**REGULAR MEETING OF THE PLANNING BOARD
WEDNESDAY, JANUARY 25, 2017
7:30 PM
CITY COMMISSION ROOM
151 MARTIN STREET, BIRMINGHAM**

SUBJECT: 33353 Woodward – Final Site Plan & Design Review

The subject site is located at 33353 Woodward, on the west side of Woodward between Davis Ave. and Smith Ave. and is the current location of Tuffy Automotive repair. The plan proposes to demolish the existing structure and parking lot to construct a new one story multi-tenant building and on-site parking. The property is zoned B2-B General Business. The new tenants of the building have not been determined but the potential mix of uses will be restricted by the available parking. The applicant was granted Preliminary Site Plan approval on November 9, 2016 with the following conditions:

A010
ARCHITECTURAL SITE PLAN

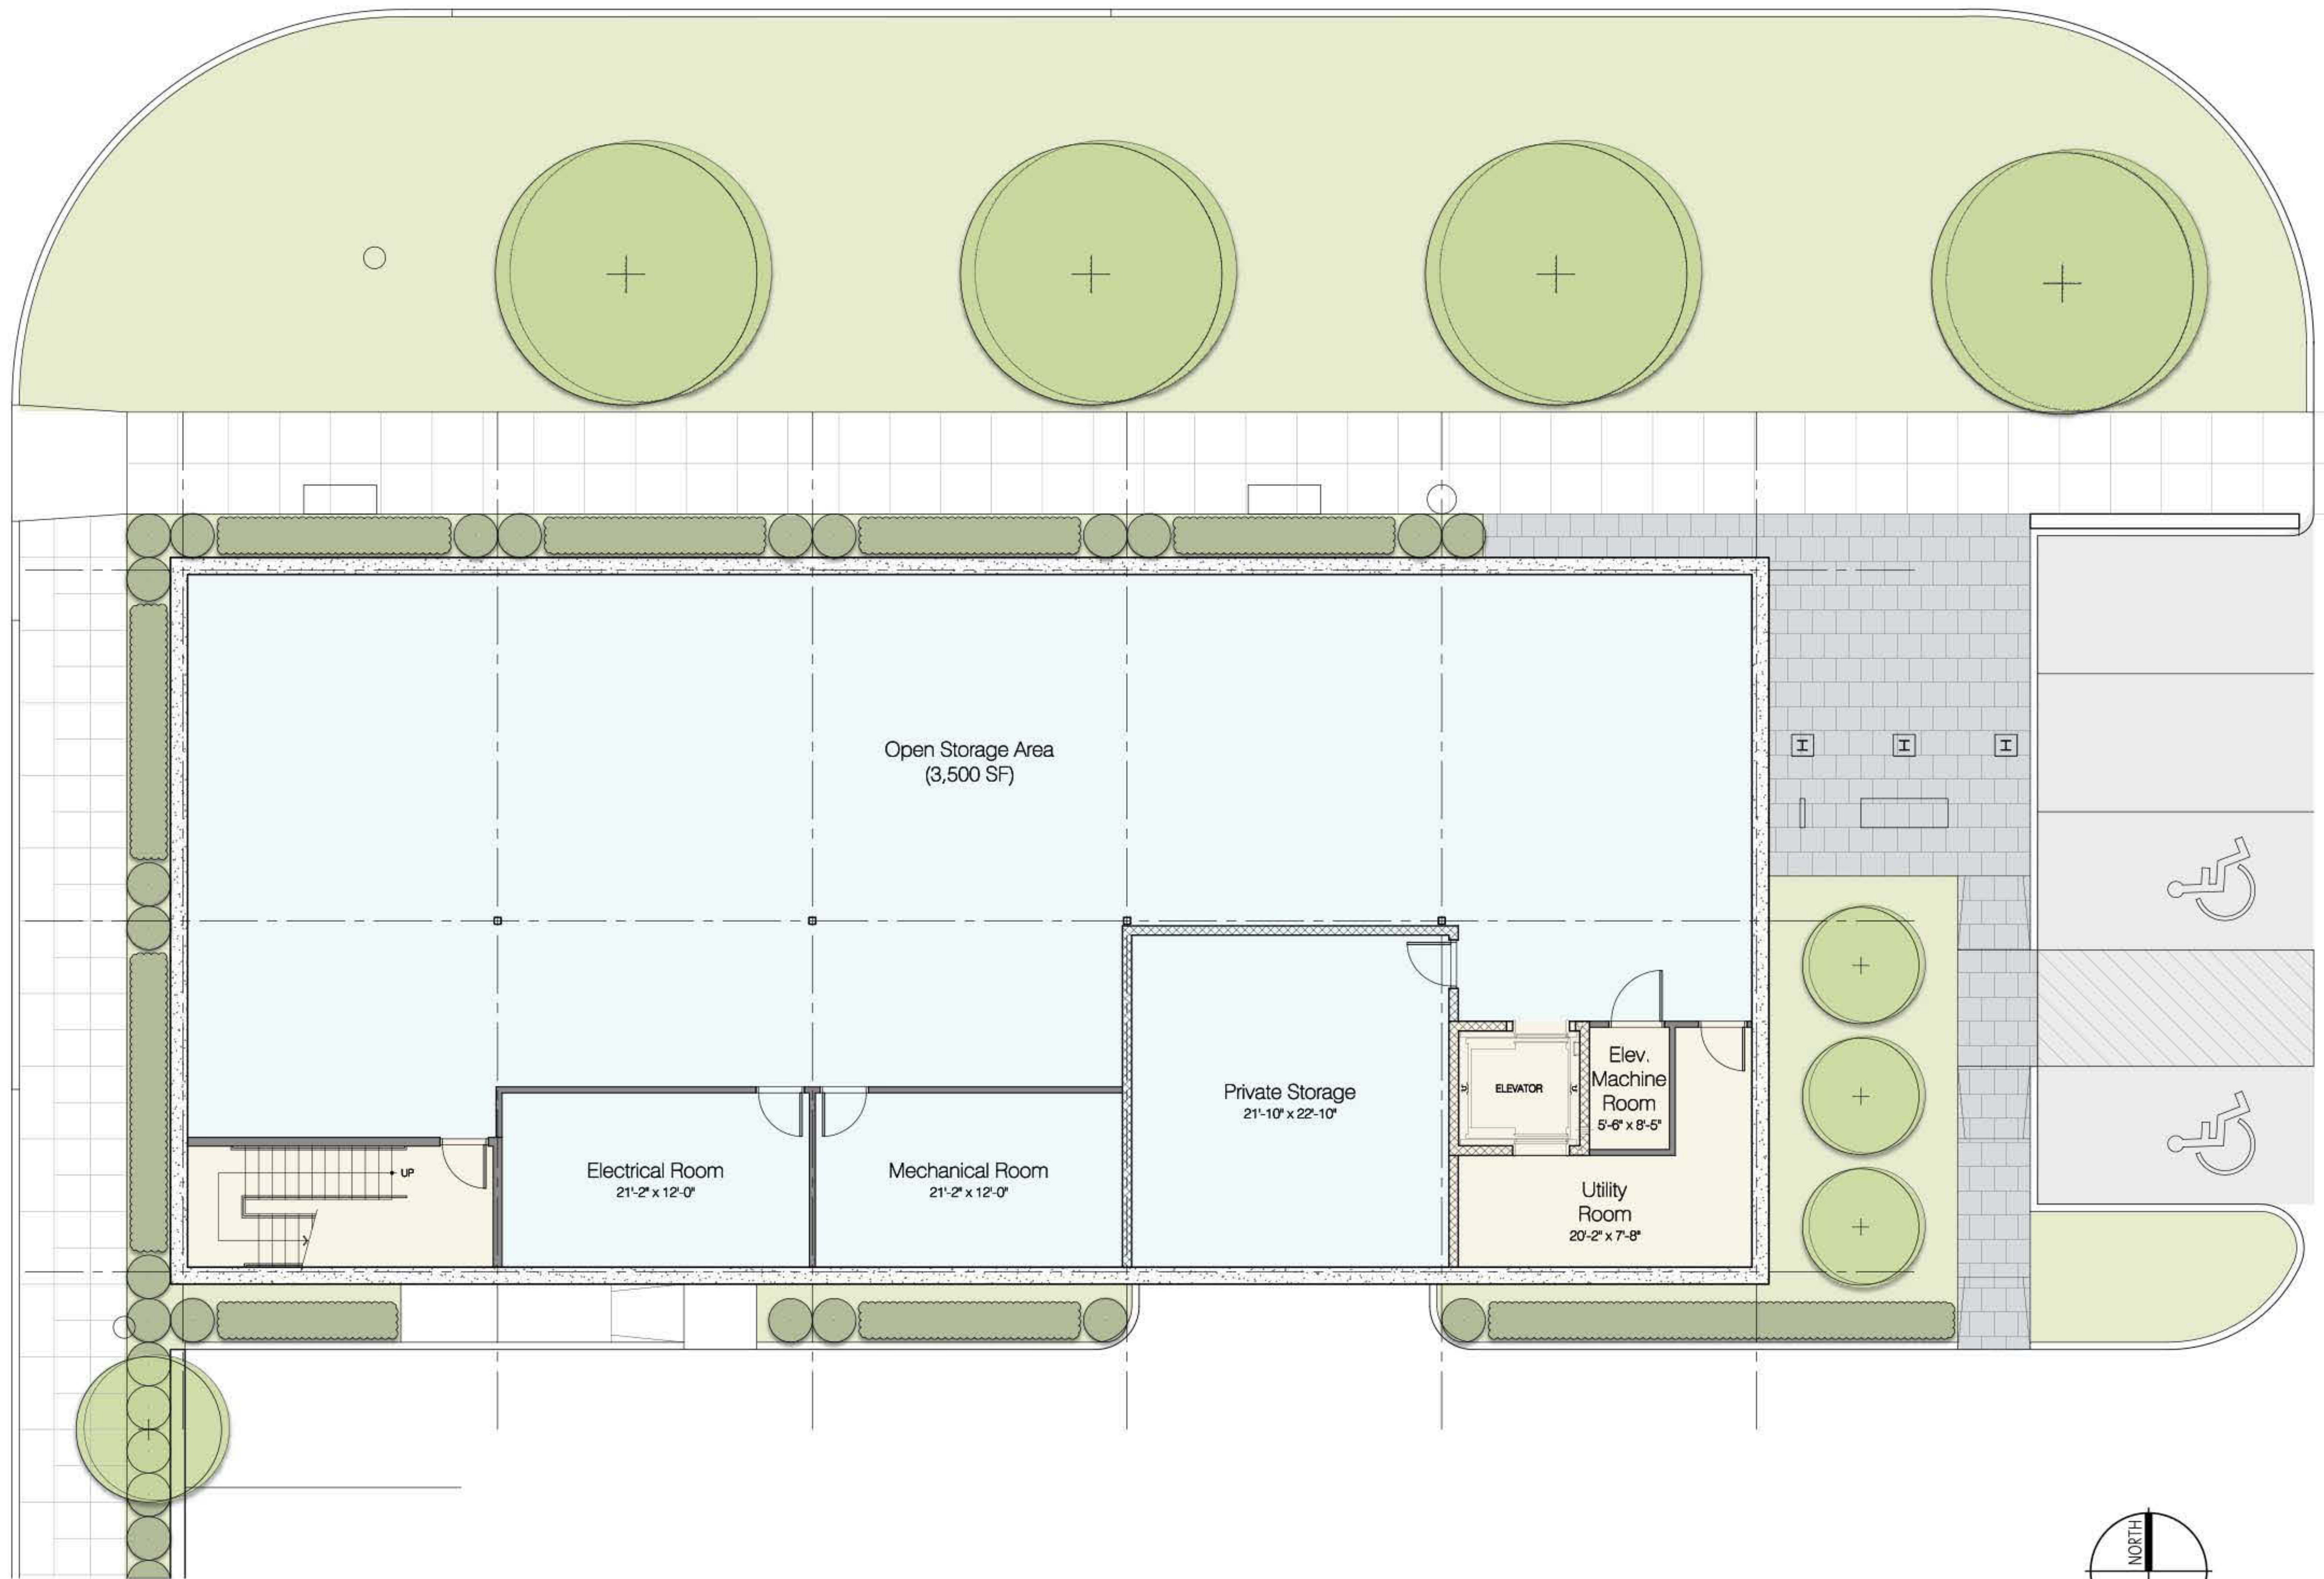
As demonstrated in sheet C-3, the proposed parking lot will maintain at a drive aisle of at least 20' in width, providing sufficient room for vehicular maneuvering. The applicant proposes a private parking garage for two cars on the first floor with access from the south elevation. However, the applicant has not provided the width of the parking garage openings at this time. **In accordance with Article 3, Section 3.04 (C) (7) of the Zoning Ordinance, openings for parking garage access shall repeat the same rhythm and proportion as the rest of the building to maintain a consistent streetscape. The applicant is required to provide the width of the parking garage opening to demonstrate compliance with this provision. It appears to be 16' in width if it is located on the south elevation as marked.**
